County of Fairfax, Virginia

STAFF REPORT

APPLICATION RZ 2014-PR-012

PROPOSAL: To rezone properties to permit 10 single-family detached dwellings.

SHEET 3 OF 7

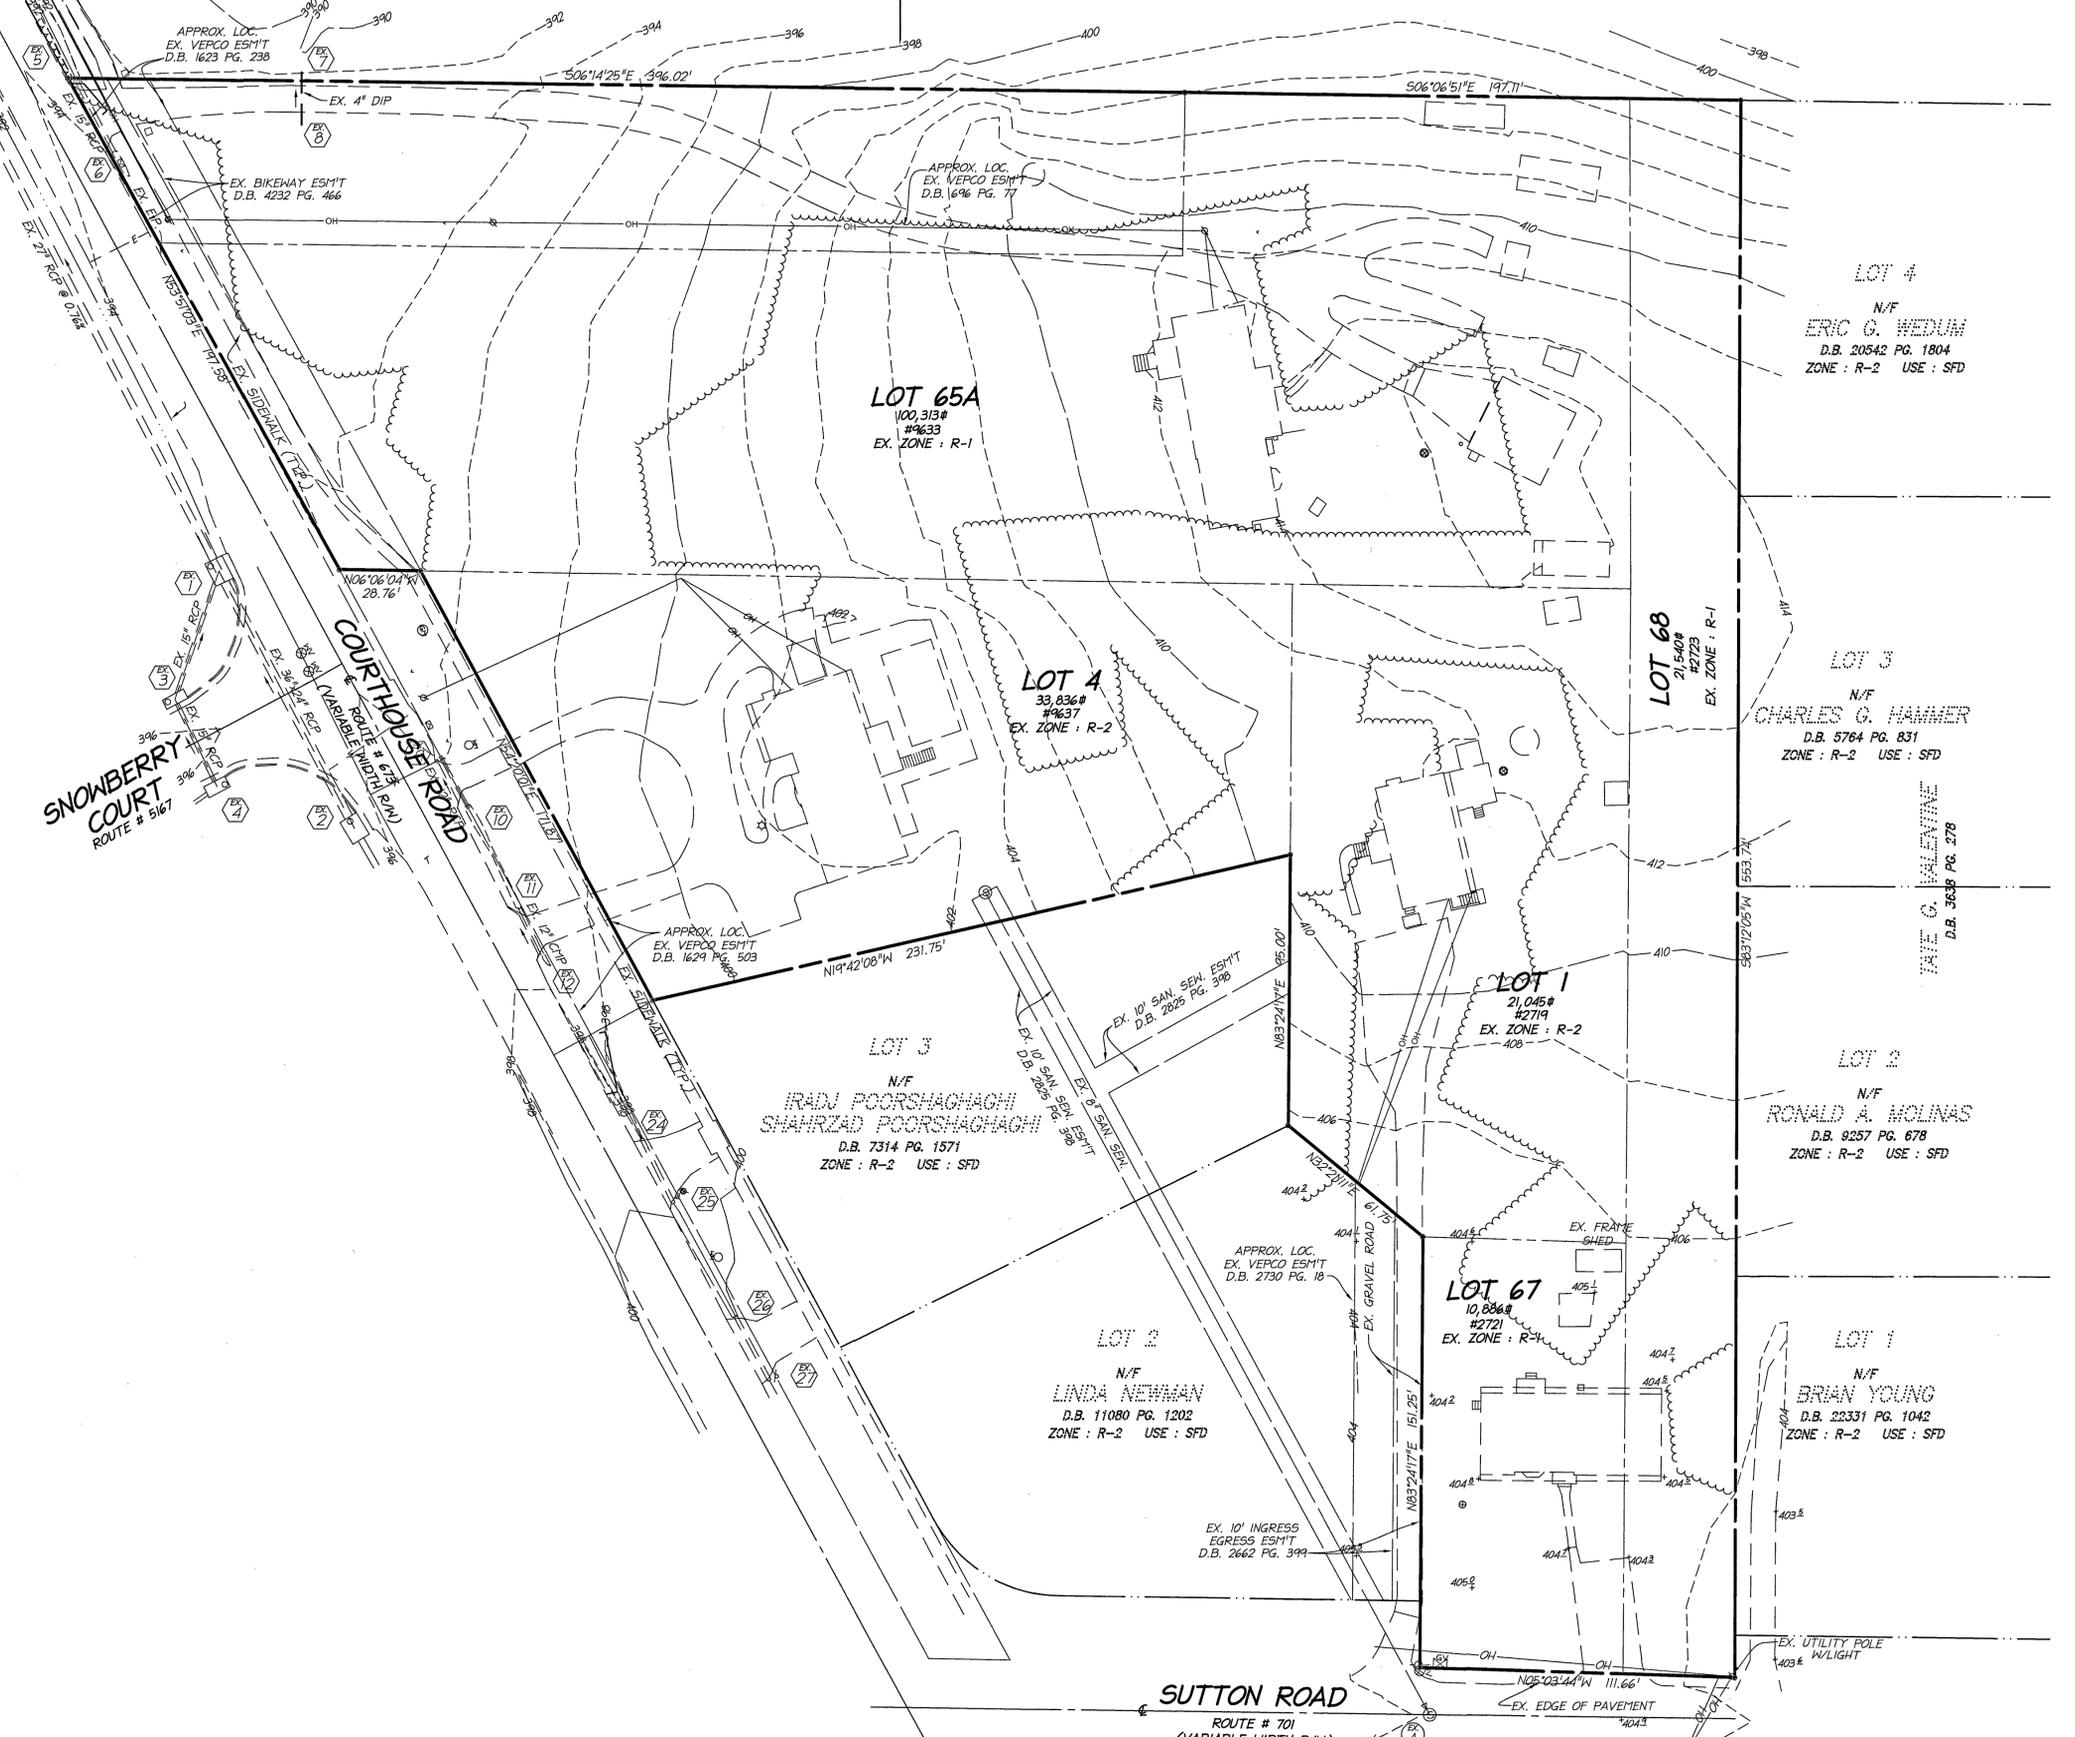
- 5. Comment:** The 6,570 sq. ft. identified as the minimum total of canopy area provided through tree planting, as indicated in lines D17 and E2 of the 10-year Tree Canopy Calculations on sheet 7, is inconsistent with the total sq. ft. identified on the Plant Schedule on sheet 3.

Figure 8 Predeveloped Drainage Area

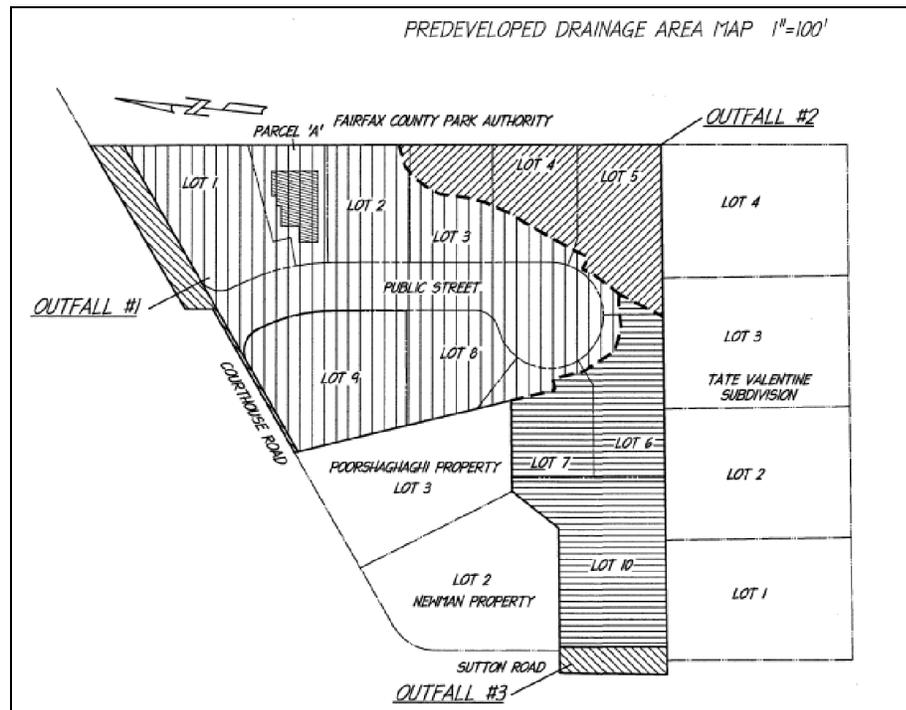
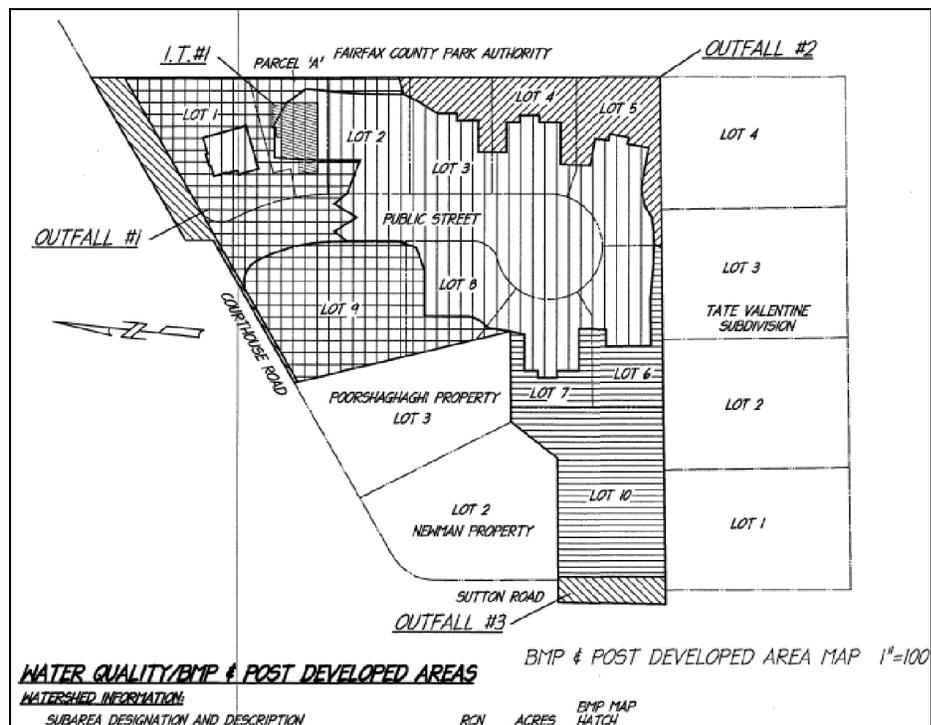
During review of this application, a key topic has been the treatment of the volume and velocity of stormwater leaving the site. While the site is somewhat developed in its existing condition, the proposed development will generate a higher levels of drainage outfall than currently experienced.

In the post developed circumstance, outfall still is provided to the same three outfalls; however, its velocity and volume is treated in the infiltration trench prior to reaching the outfalls. Detention for the two- and ten-year storm event and storage for the one-year storm volume will be provided. These outfalls have been reviewed by the Department of Public Works and Environmental Services (DPWES) and are adequate in accordance with the PFM. The proffers also commit that the stormwater facility shall be designed to meet the adequate outfall as outlined in the PFM. The current design does eliminate the current impervious area which sheet flows into Nottoway Park.
